SERVICE INFORMATION LETTER

SERVICE INFORMATION LETTER INDEX

FIGURE 1

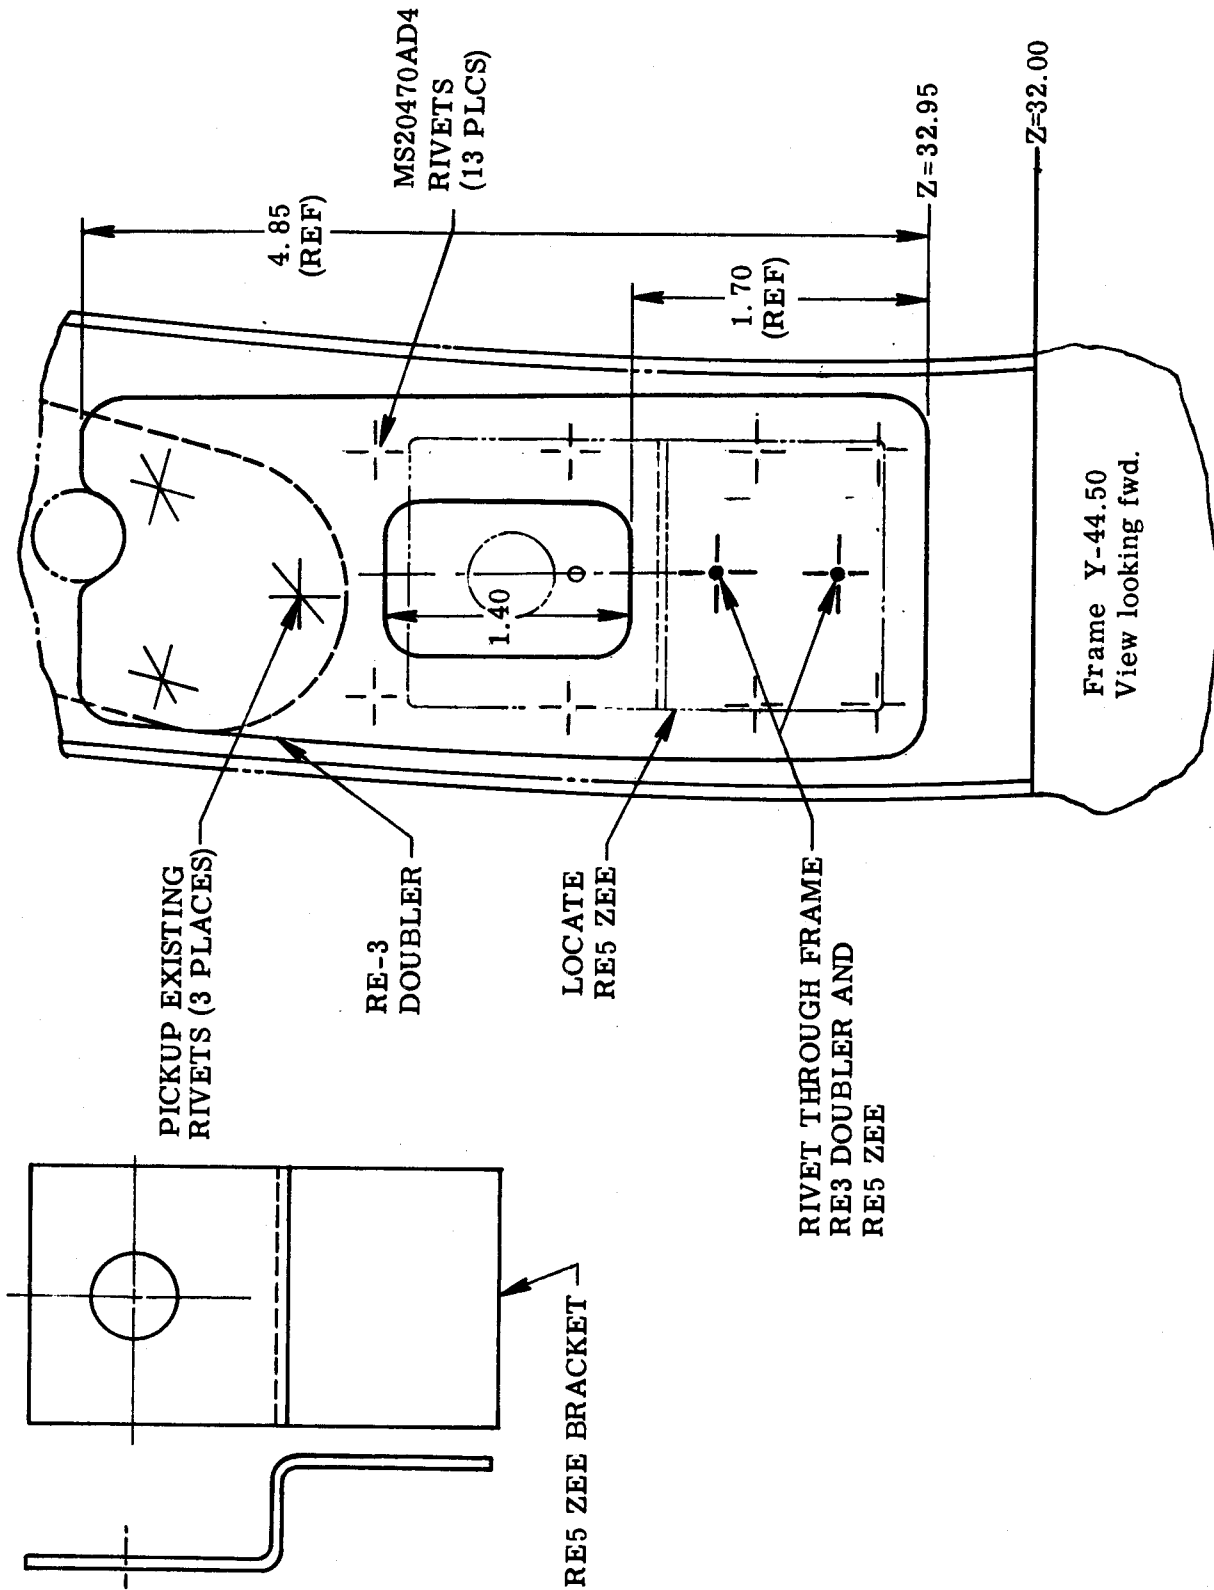
6. Install RE3 doubler and RE5 zee bracket on Fus. Sta. 44.50 frame in accordance with Figure 1.
7. Temporarily replace pilots side panel to permit locating and marking position for RE7 placard installation. Mark center of hole to be drilled to accommodate nose steering sensitivity switch installation.

9. Install the 1TL1-2 switch in the RE5 zee bracket that was previously installed (See Figure 1).
10. Drop overhead circuit breaker panel and remove and discard existing 3 amp. nose steering circuit breaker. Install new 5 amp. nose steering circuit breaker and secure circuit breaker panel.

FIGURE 2

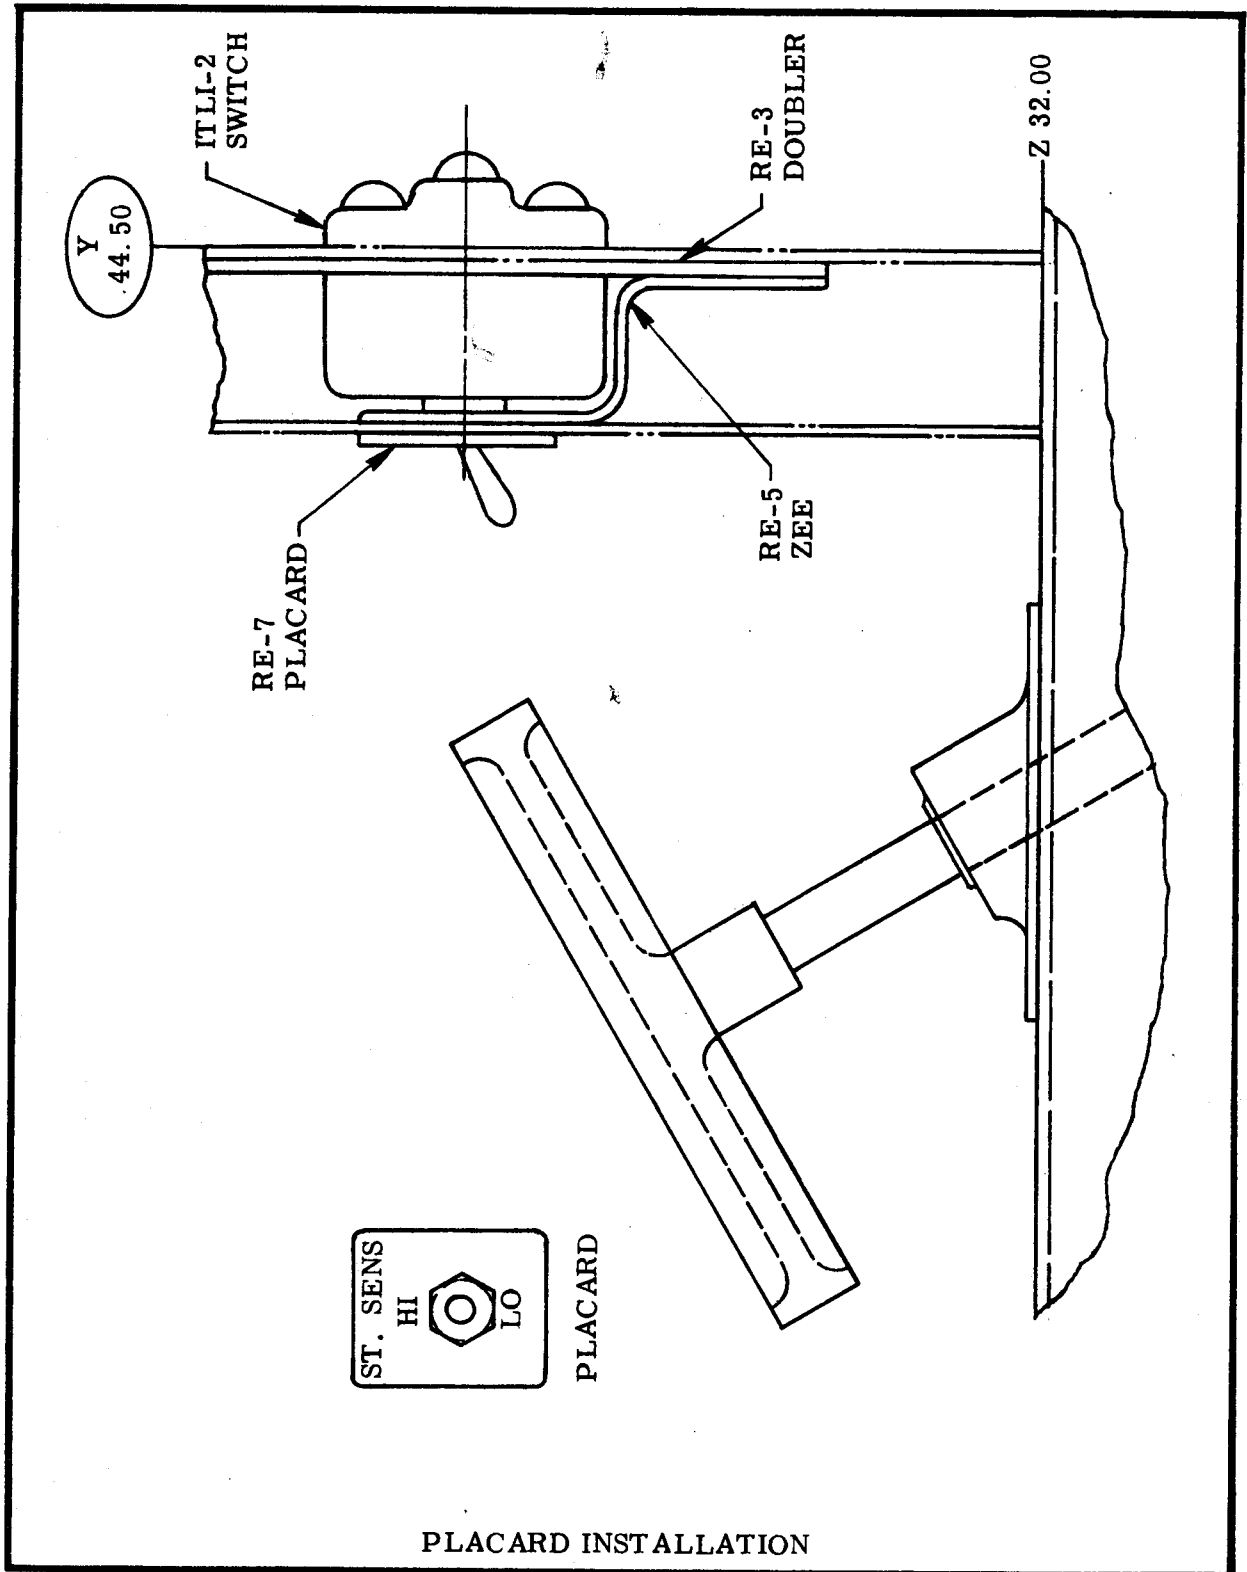
8. Remove side panel and drill 0.50 dia. hole through pilots side panel as marked. Bond the RE7 placard in place, using EC1403 cement or equivalent, as per Figure 2.

FIGURE 3A

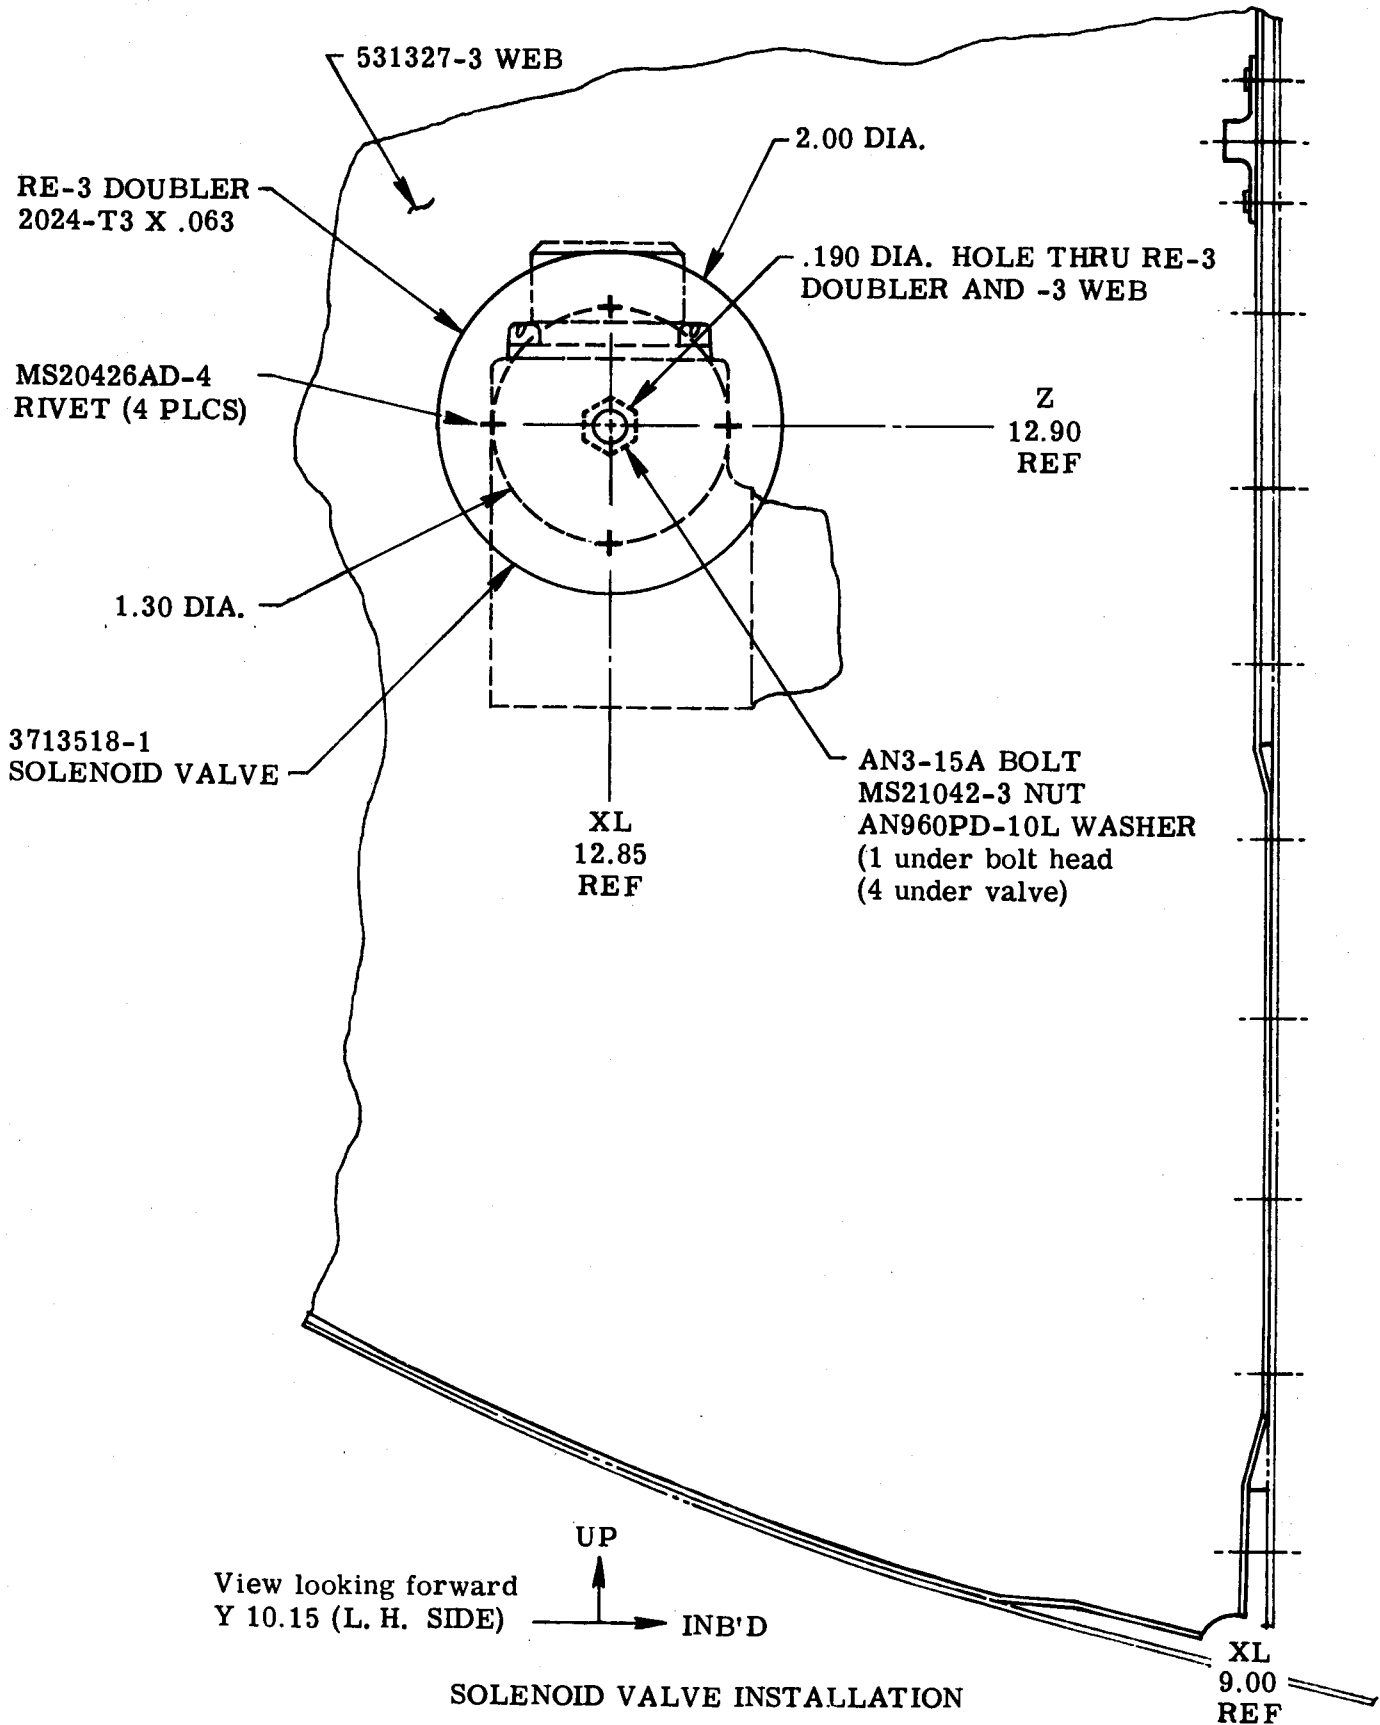
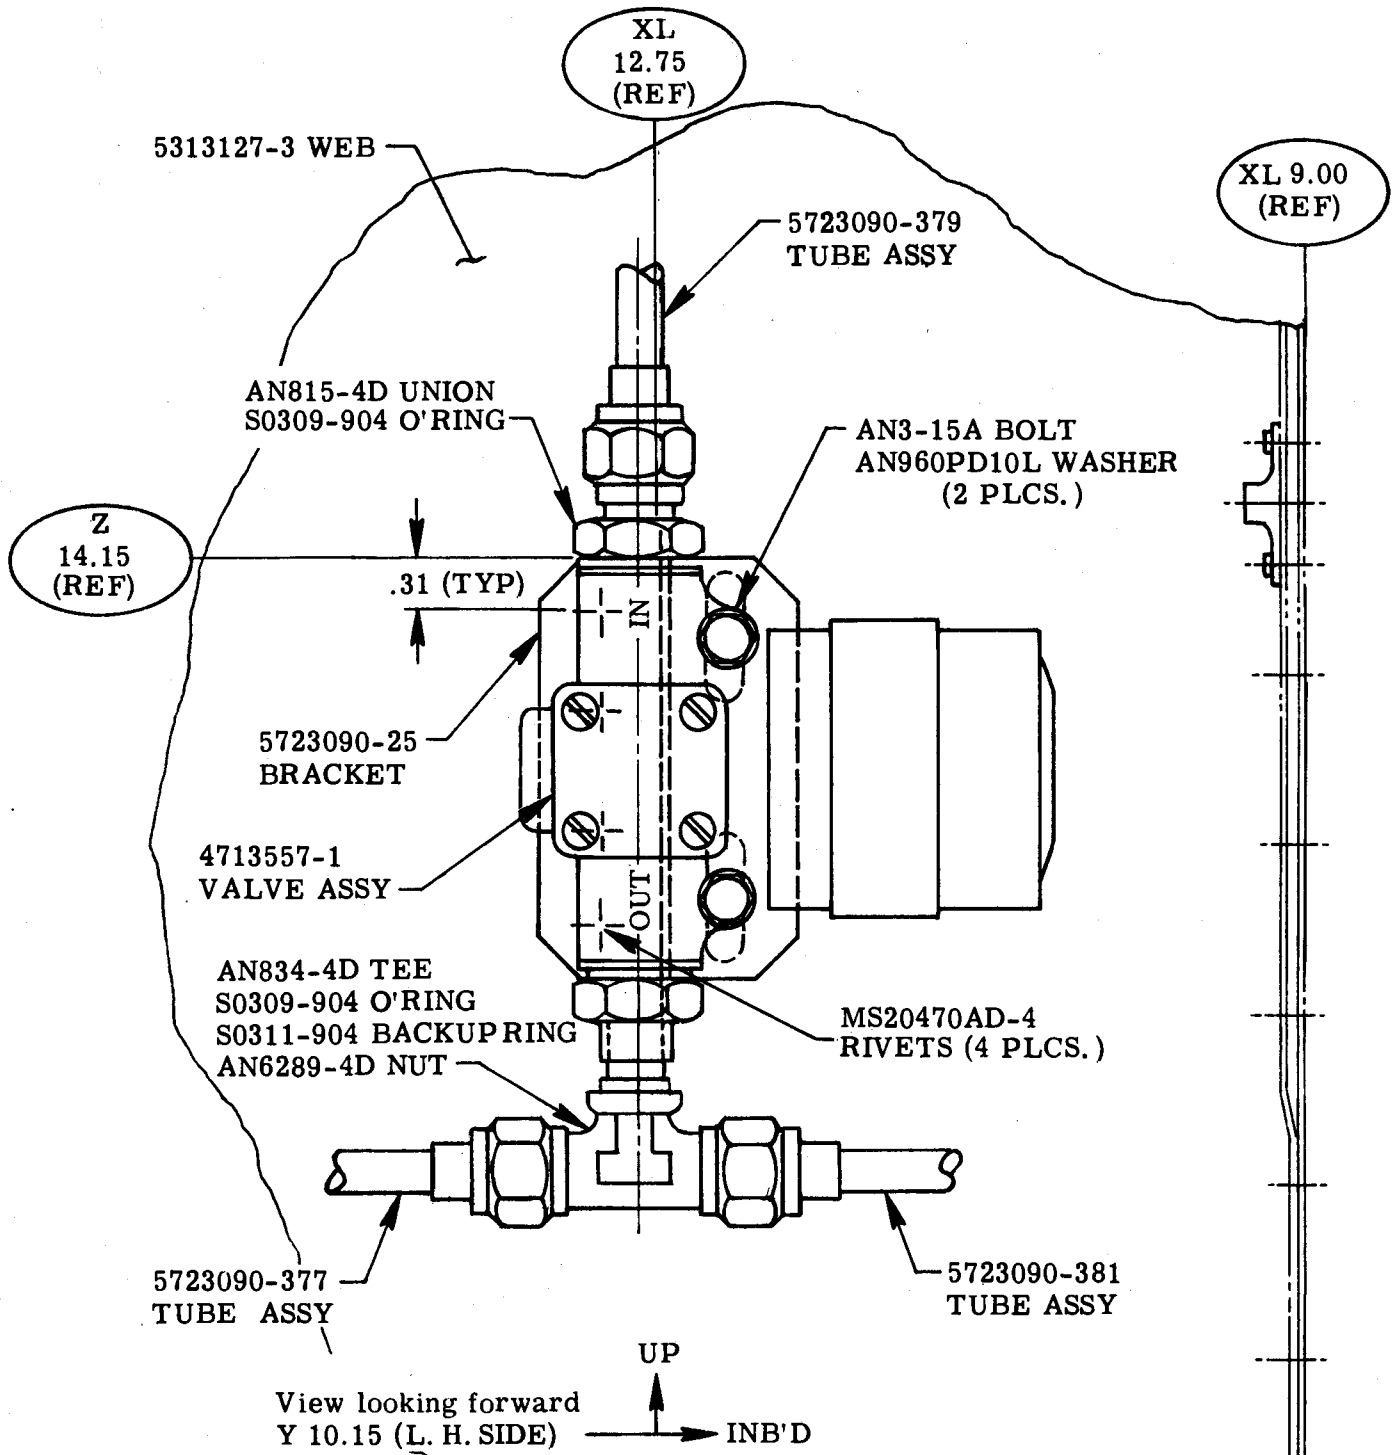
REASON FOR REVISION: TO CORRECT TUBING PART NUMBERS IN FIGURE 3A, CHANGE CONNECTOR PART NUMBER IN SUPPLY DATA AND ADD TUBE CLAMPING INFORMATION

1. Reference Figure 3A:
 - A. Tubing P/N 5723090-377 changed to 6723088-377.
 - B. Tubing P/N 5723090-379 changed to 6723088-379.
 - C. Tubing P/N 5723090-381 changed to 6723088-381.
2. The MS3106E-14S-9S Connector in Kit "B" is replaced by Connector P/N MS3456L-10SL-4S or MS3108B-10SL-4S.
3. Clamping information for tube P/N 6723088-349 or (-377) as applicable.
 1. Drill a 0.190 - 0.194 hole in the Y-10.15 bulkhead at the intersection of Fuselage Station X-16.0 and Z-21.6.
 2. Install hydraulic tubing support clamp P/N MS21919DG4, using an AN3-12A bolt, NAS43DD3-50 bushing and MS21042-3 nut.
 3. The required hardware for Para. 2 may be obtained from local source.

- B. Install the Solenoid Valve P/N 4713557-1 and the 5723090-25 bracket (Kit "B") as per Figure 3A.
13. Install the VXLA2500270D Restrictor with S0309-904 O-ring on the AN783-4D tee fitting, per Figure 4.
